Issued by: Sächsische Spezialkonfektion GmbH
Nordstr. 40
02782 Seifhennersdorf
GERMANY

Subject: Pilot Chute at Emergency Parachutes,
Type RE-5L, Seria 4 und 5, (LBA.040.010/89 JTSO)
Manufact.-No.: 72245 – 72371, except 72370
Manufact. Date: 21.04. – 21.08.2008 (Date of EASA
Form 1)

Enclosure to SAFETY BULLETIN No. 01/2008

Fig. 1: Pilot chute

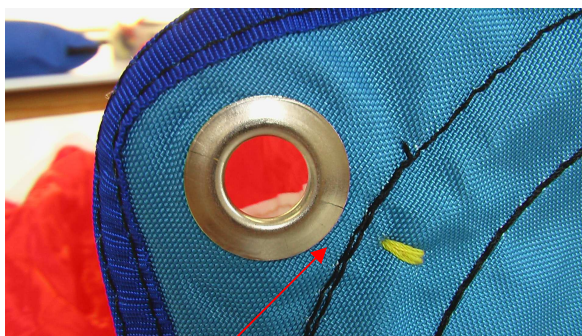
Reason: Pilot chutes as part of Emergency Parachutes RE-5L,
produced and delivered in-between the above mentioned
period, may have damaged (chapped) grommets at the top
(see Fig. 2).
In extreme case it may happen an obstruction of the closing
loop by a damaged grommet and further on the proper
opening of the parachute container may be obstructed.

Tear

Requested action: Replacement of Pilot Chute at all Emergency Parachutes RE-5L with the Manufacturing-No's 72245 – 72371, except 72370, produced and delivered in-between the period 21.04. – 21.08.2008 (Date of EASA Form 1)
